STATE OF MAINE
DEPARTMENT OF TRANSPORTATION
16 STATE HOUSE STATION
AUGUSTA, MAINE 04333-0016

October 30, 2023
Subject: Bridge Deck Replacement
State WIN: 025631.01
Location: **Medway**
Amendment No. 1

1-95 SB & NB VAUGHAN D'ARCEVILLE MEMORIAL BRIDGES, 1-95 SB & NB OVER ROUTE 116, & ROUTE 157 INTERCHANGE BRIDGE

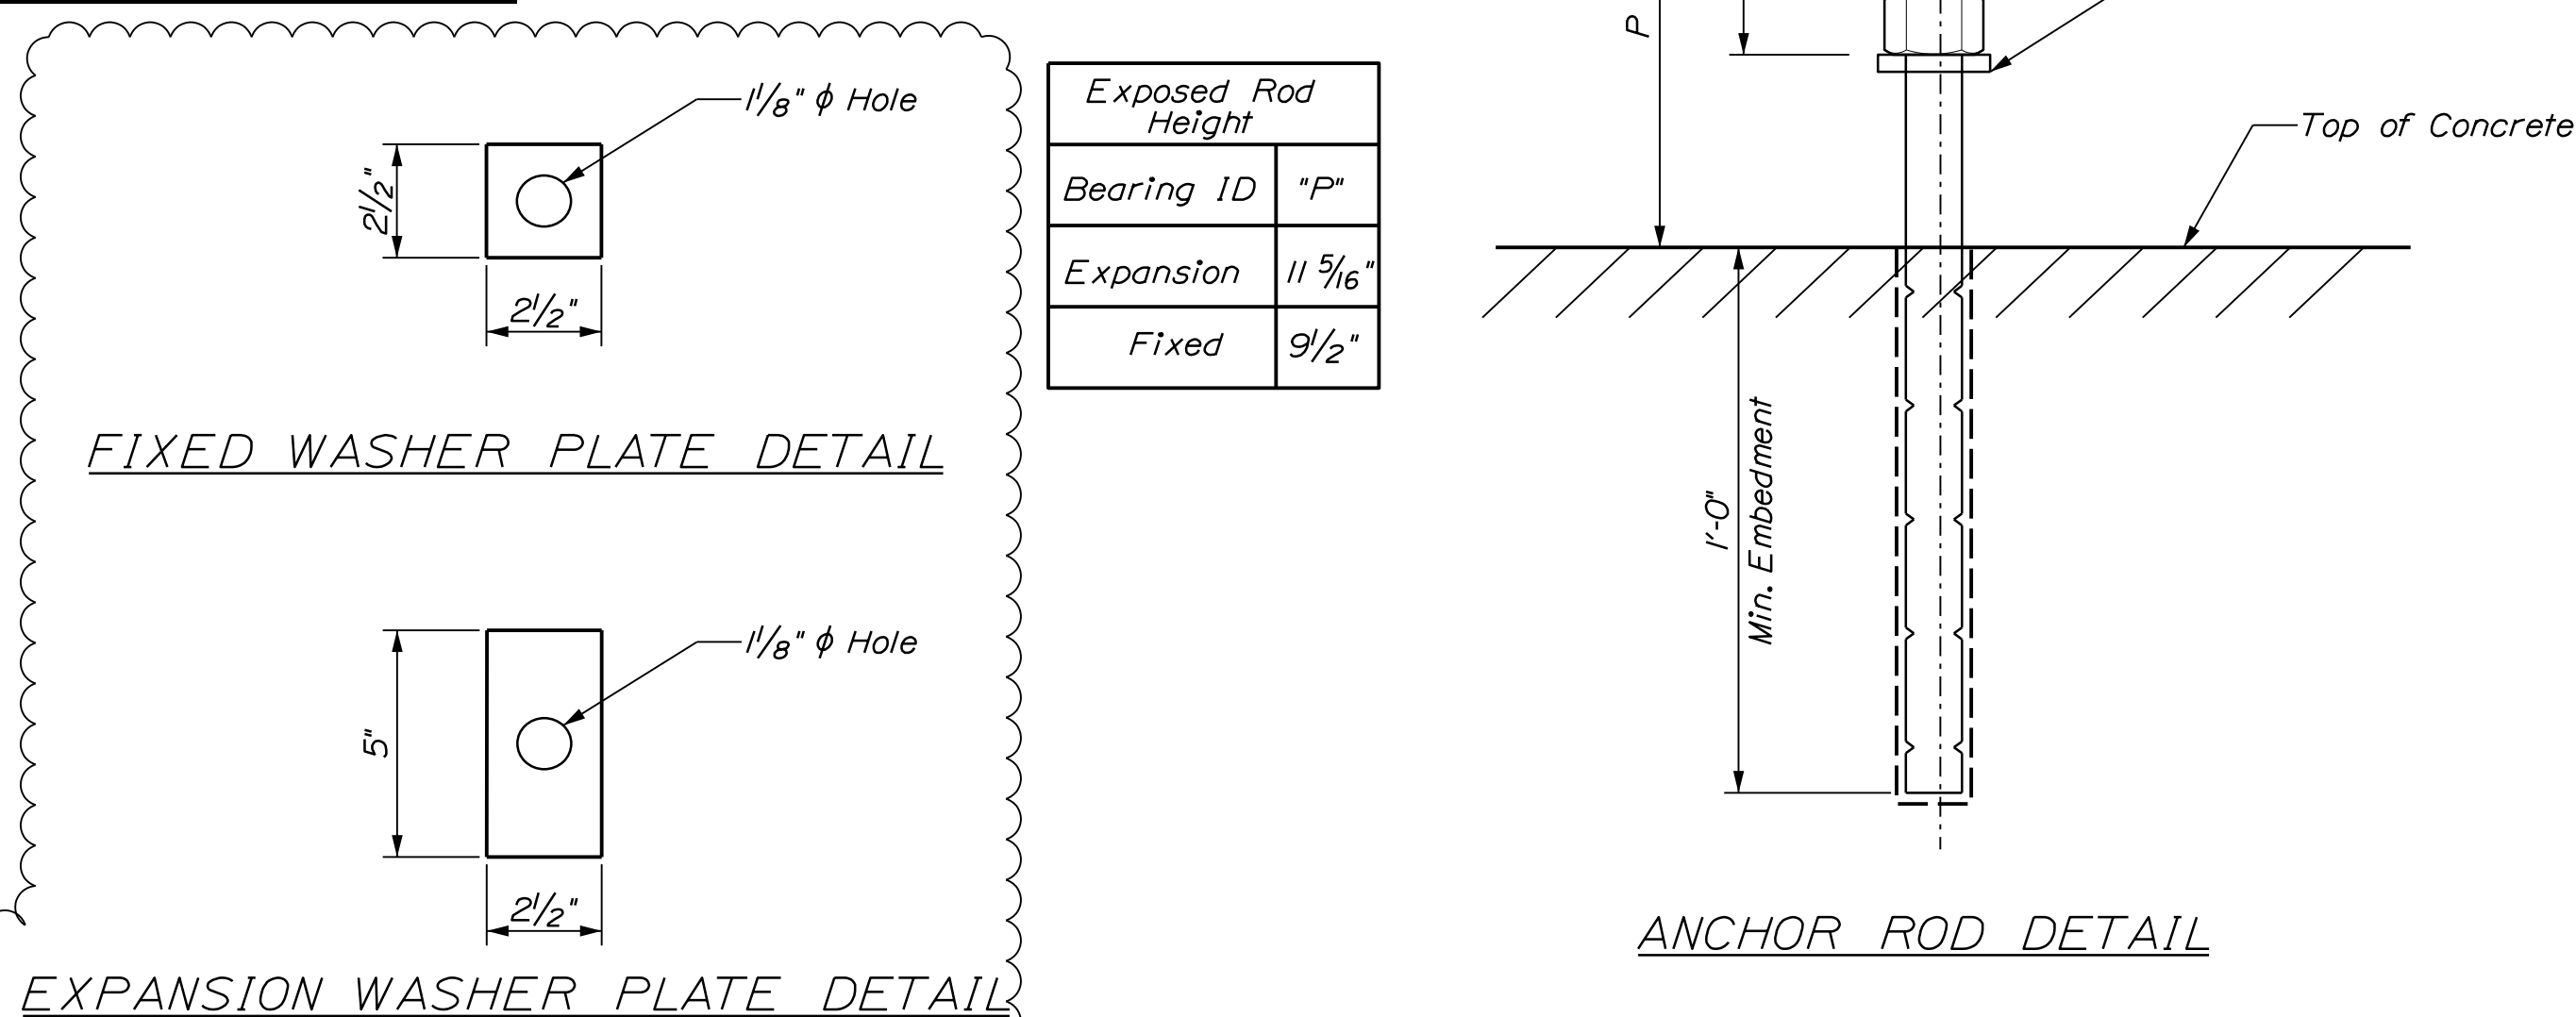
Question: Note One on Sheet 139 calls for the existing bearing anchor bolts to be cut and ground flush. Please confirm the new Anchor Bolt Layout does not conflict with the existing Anchor Bolts.

Response: REMOVE SHEET NUMBER 139 of 168, BEARING DETAILS dated 10/3/2023 and REPLACE with the attached SHEET NUMBER 139 of 168, BEARING DETAILS, dated 10/25/2023.
